ADDRESS: 257 S 16TH ST

Proposal: Install aluminum windows

Review Requested: Final Approval

STAFF RECOMMENDATION: Denial, pursuant to Standard 6.

PROPOSED WINDOW
DETAILS

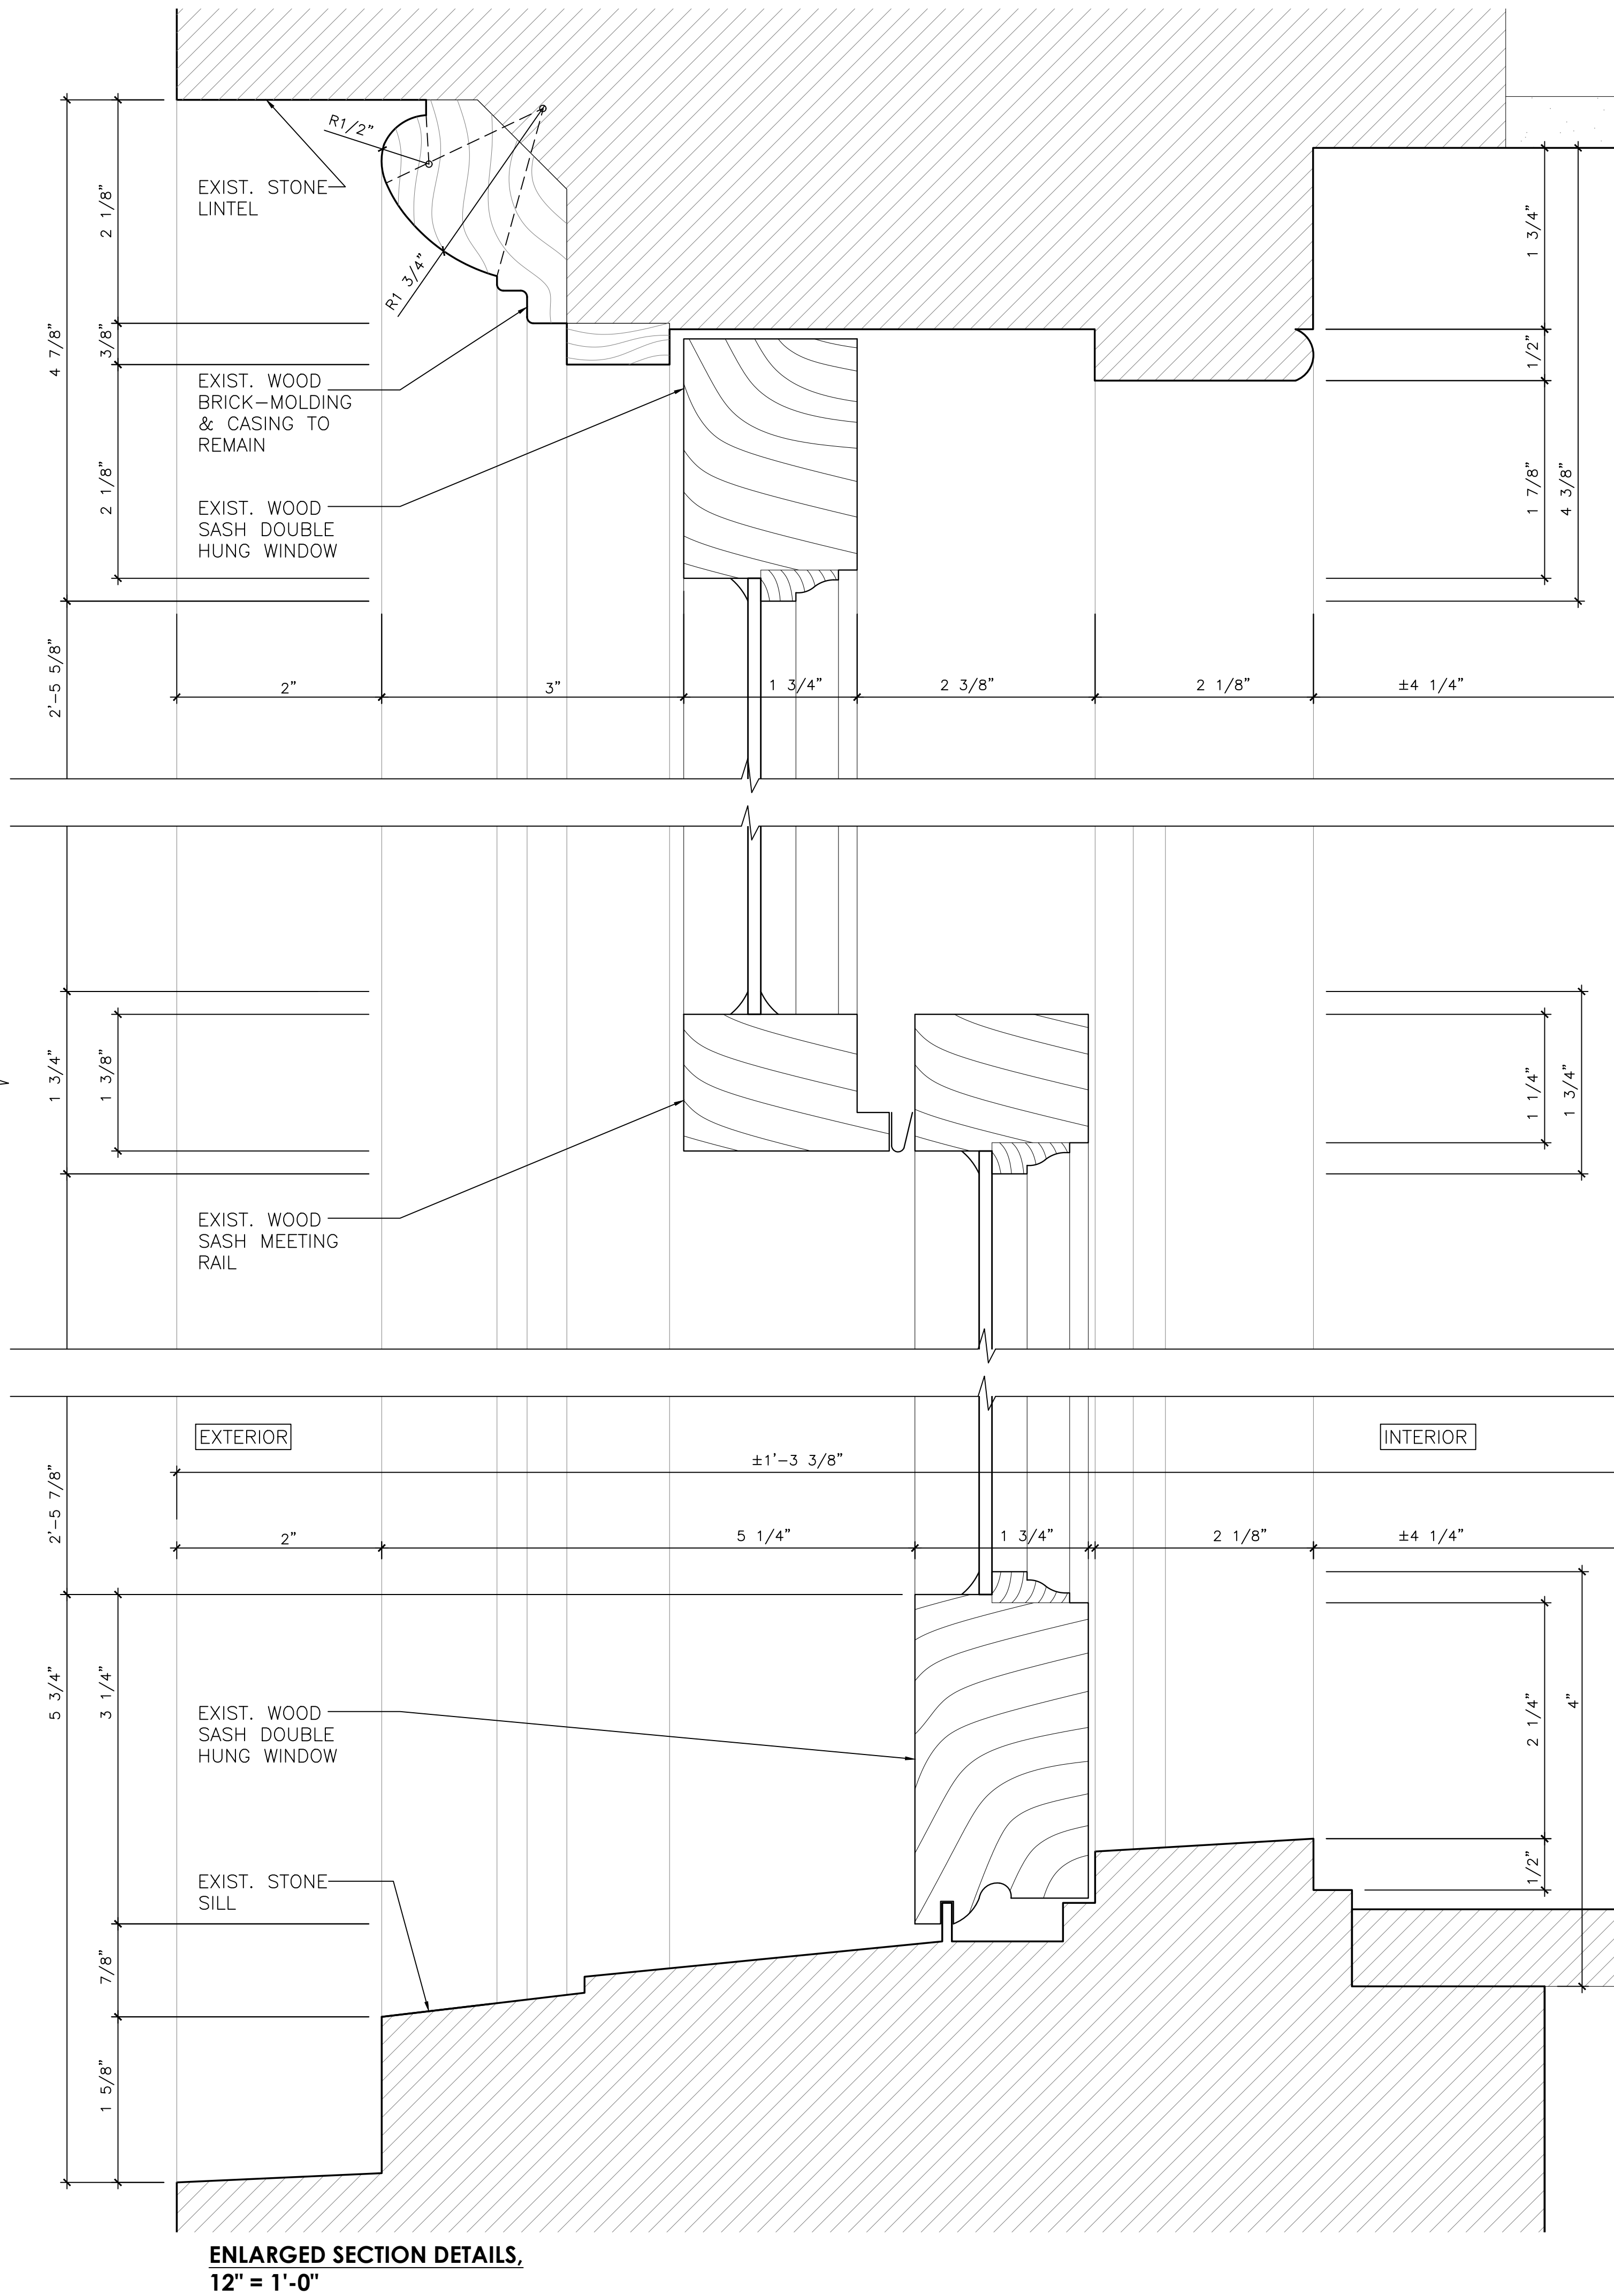
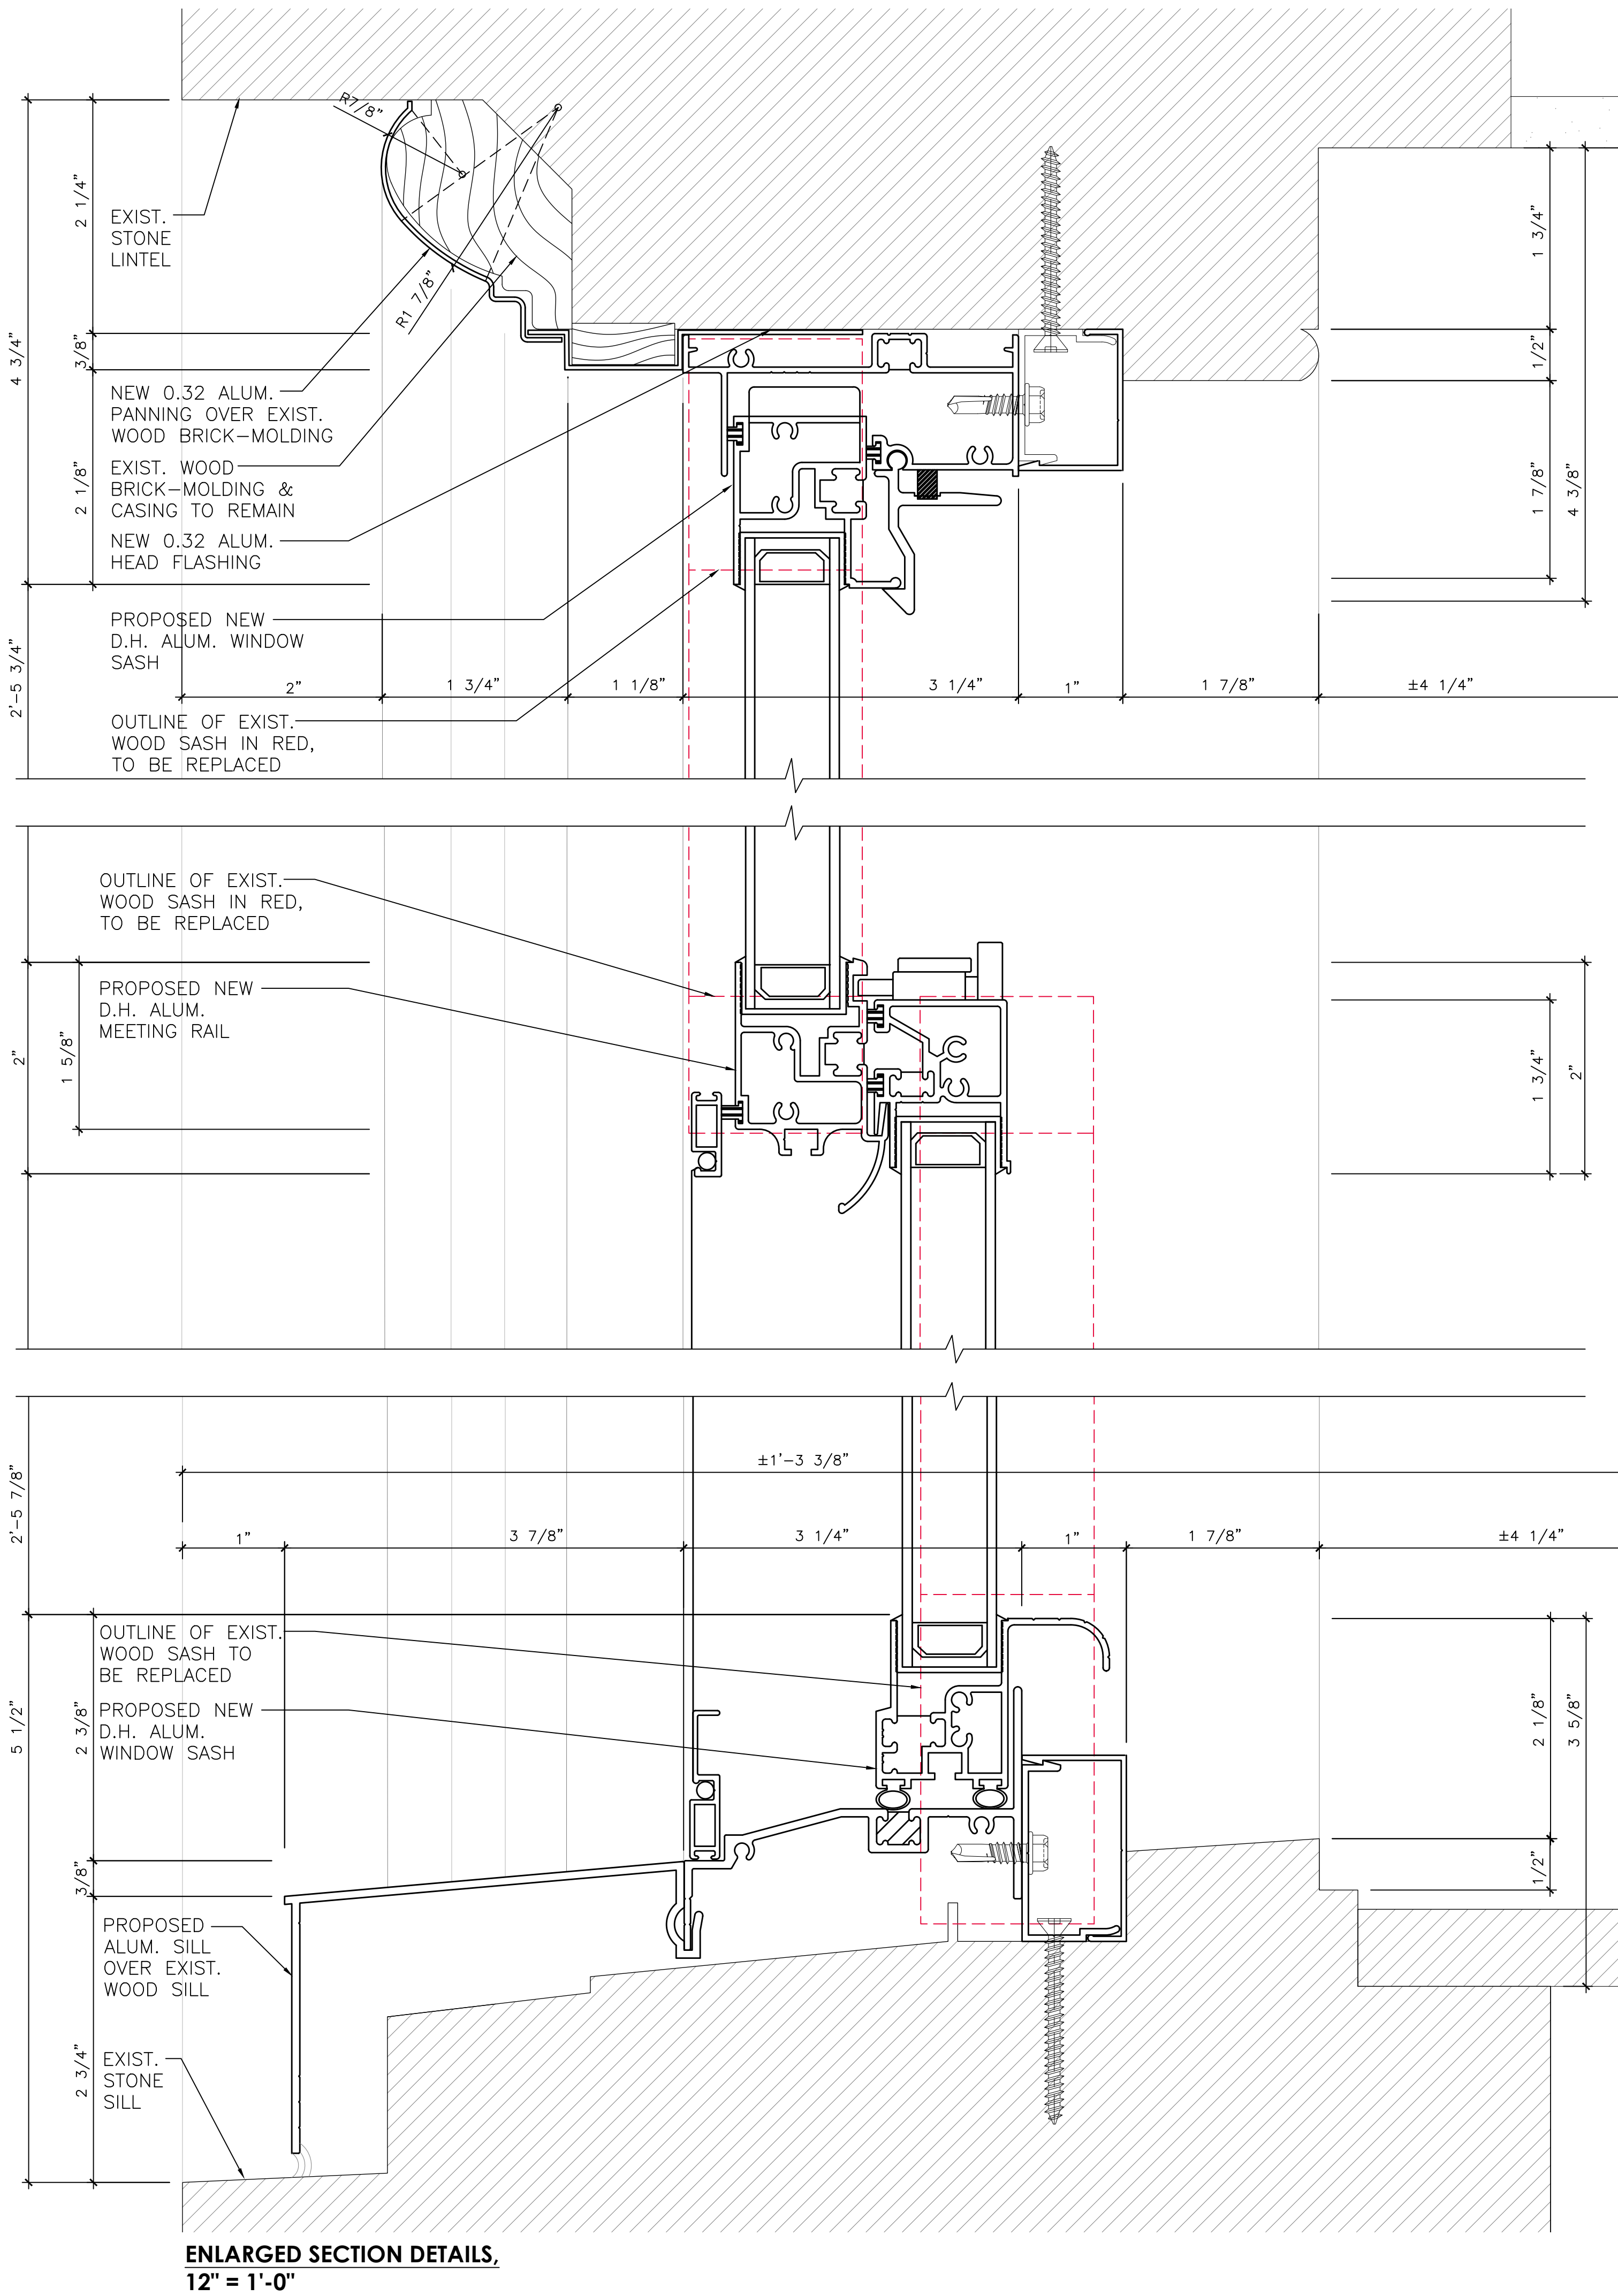
- *Standard 6: Deteriorated historic features shall be repaired rather than replaced. Where the severity of deterioration requires replacement of a distinctive feature, the new feature shall match the old in design, color, texture, and other visual qualities and, where possible, materials. Replacement of missing features shall be substantiated by documentary or pictorial evidence.*
 - o The proposed aluminum system has a significantly flatter profile between the sash and the glazing, changing the spatial relationships and visual qualities as well as texture of the original windows. The proposed aluminum windows do not replicate the appearance of the historic wood windows, failing to satisfy Standard 6.
